HISTORIC AND DESIGN REVIEW COMMISSION

April 06, 2022

HDRC CASE NO: 2022-149
ADDRESS: 326 RIVERSIDE DR
LEGAL DESCRIPTION: NCB 7672 BLK 21 LOT NW 170 X 15 OF 5, N IRR 190 OF 6, N 207.86 OF 7, N 207.86 OF E 102 OF 8
ZONING: IDZ-1, H, RIO-5
CITY COUNCIL DIST.: 3
DISTRICT: Mission Historic District
APPLICANT: Nicholas Melde/Architexas
OWNER: Peter Greenblum/326 RIVERSIDE LLC
TYPE OF WORK: Exterior modifications, construction of a rear addition, fenestration modifications
APPLICATION RECEIVED: February 28, 2022
60-DAY REVIEW: Not applicable due to City Council Emergency Orders
CASE MANAGER: Edward Hall
REQUEST:

3 Roof Plan
1/4" = 1'-0"

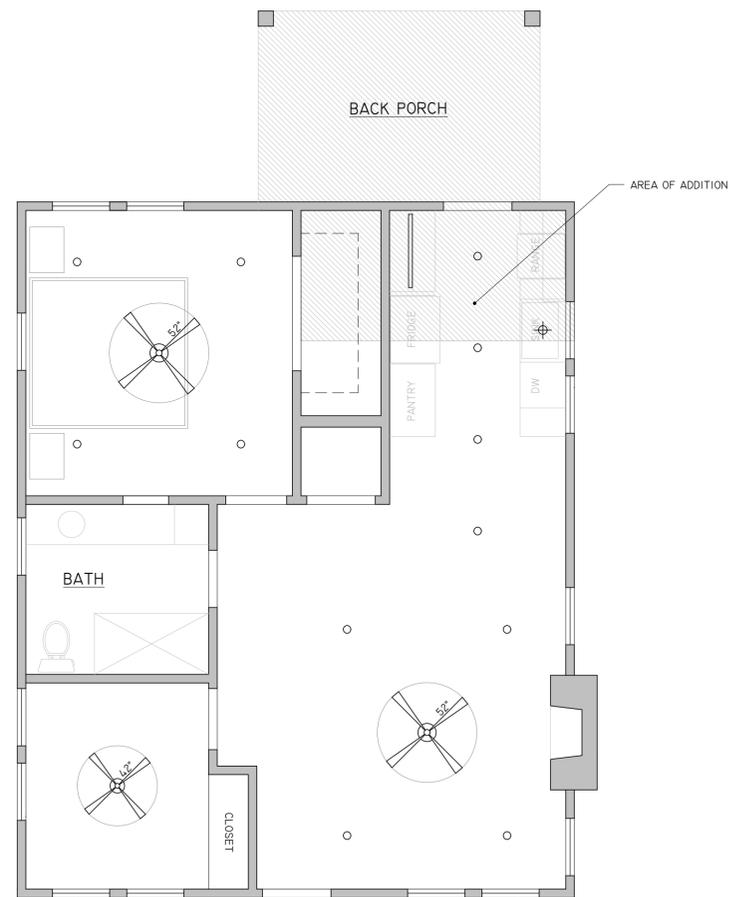
- c. ROOF REPLACEMENT – The applicant has proposed to replace the existing, shingle roof with a standing seam metal roof. Standing seam metal roofs on Craftsman structures are vernacular to San Antonio. Staff finds the proposed replacement to be appropriate provided that the replacement roof feature panels that are 18 to 21 inches wide, seams that are 1 to 2 inches in height, a crimped ridge seam and a standard galvalume finish. Panels should be smooth with no striations or corrugation. A roofing inspection must be scheduled with OHP staff to inspect the materials prior to installation.

1. Staff recommends approval of item #1, the installation of a standing seam metal roof with the following stipulation:
 - i. That the replacement roof feature panels that are 18 to 21 inches wide, seams that are 1 to 2 inches in height, a crimped ridge seam and a standard galvalume finish. Panels should be smooth with no striations or corrugation. A roofing inspection must be scheduled with OHP staff to inspect the materials prior to installation.

2 Elevation - Northeast
1/4" = 1'-0"

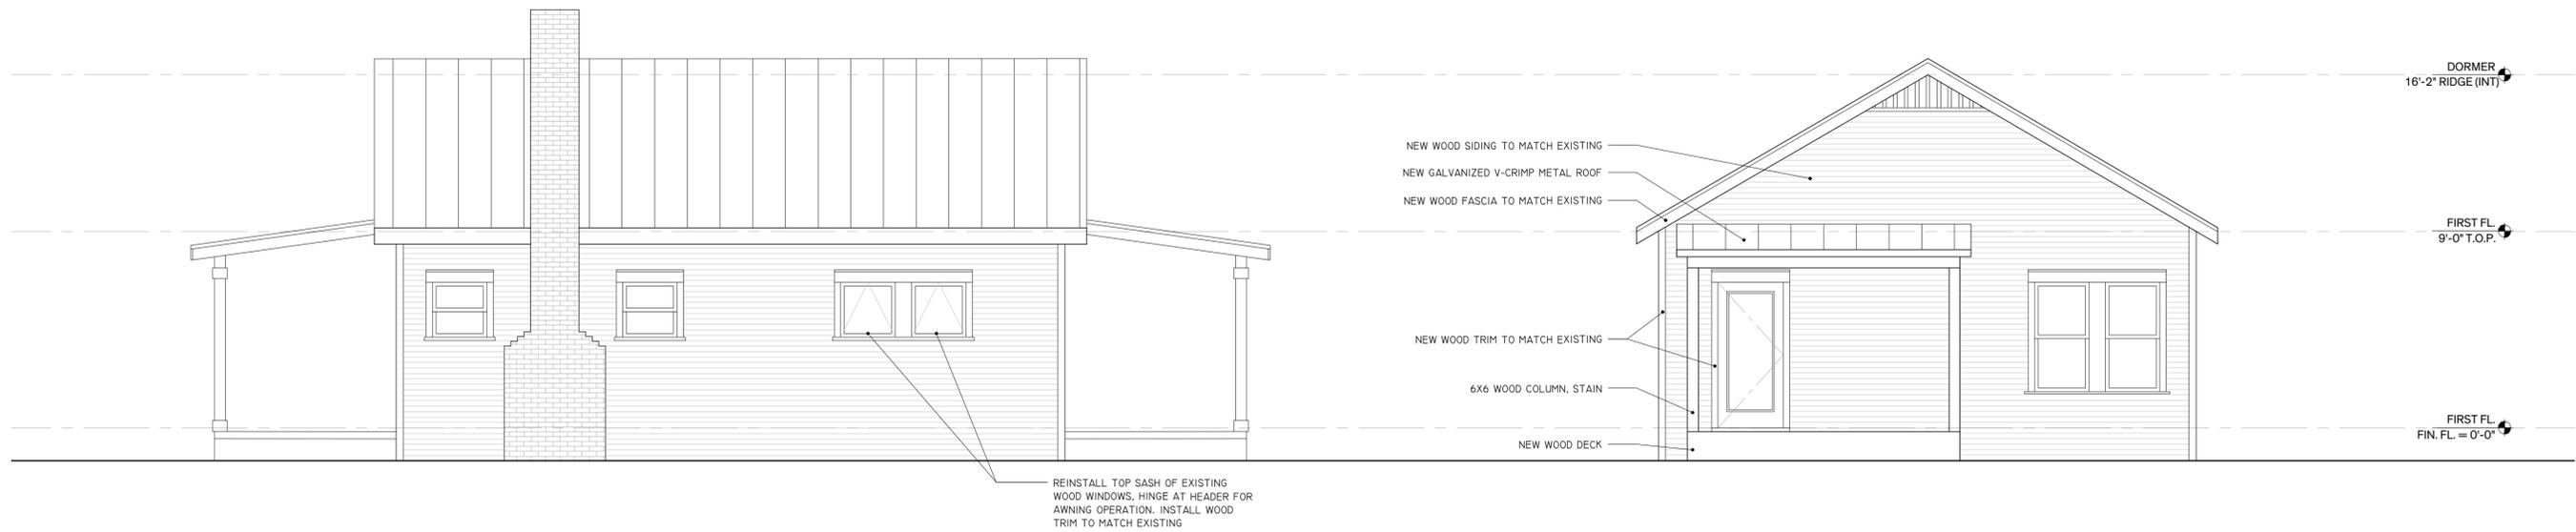
- f. FENESTRATION MODIFICATIONS (Northeast Façade) – The applicant has proposed to perform fenestration modifications to the northeast façade by relocating two window openings and modifying their sill heights. The Guidelines for Exterior Maintenance 6.A.i. notes that exterior window and door openings should be preserved. Staff finds that the existing window openings should be preserved in their current location and that their original profile should be maintained.

4. Staff does not recommend approval of item #3, fenestration modifications to the northeast façade based on finding f. Staff recommends the northeast façade be maintained as it exists and that windows maintain their current profile.
